**April 1, 2019**

## Technical Bulletin TB-2019-01

# ARCA Picture Framing Detail 2-Ply Modified Bituminous Roofing

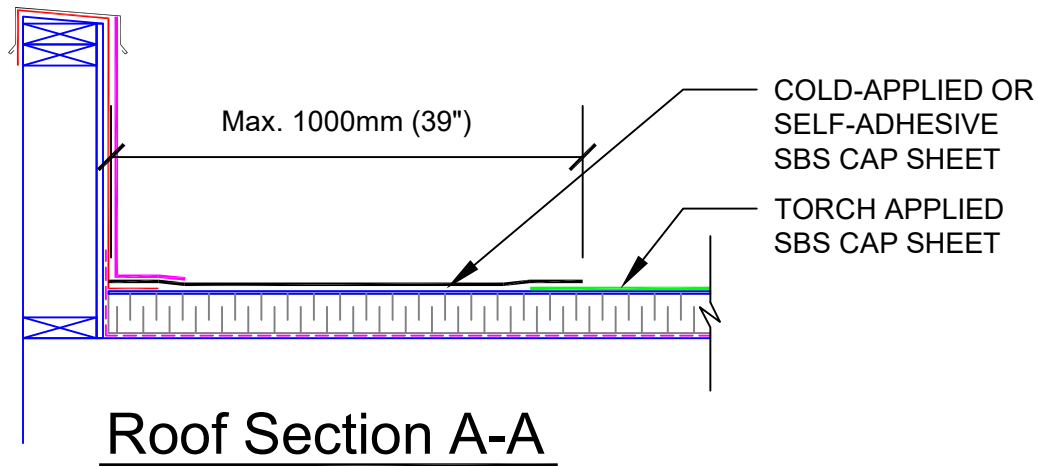
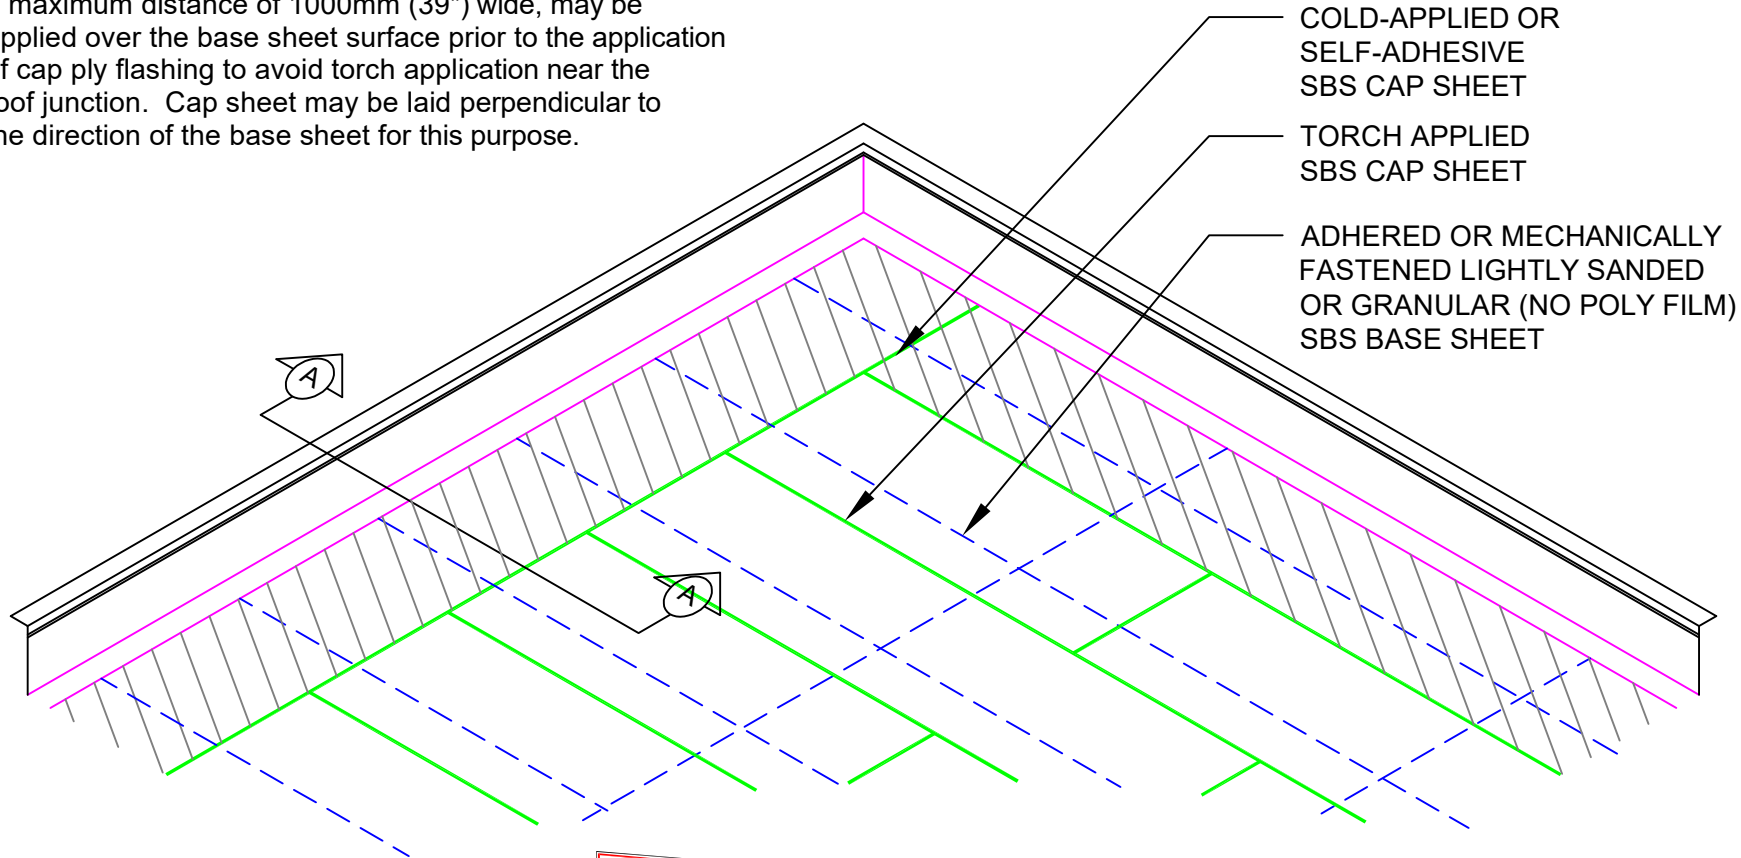
MB 7.3.1.6.  
 Sheet membranes shall have no poly film on the surface (i.e. lightly sanded or granular) to accept primers, cold-applied adhesives or liquid-applied membranes. A cold-applied or self-adhesive field cap sheet, a maximum distance of 1000mm (39") wide, may be applied over the base sheet surface prior to the application of cap ply flashing to avoid torch application near the roof junction. Cap sheet may be laid perpendicular to the direction of the base sheet for this purpose.
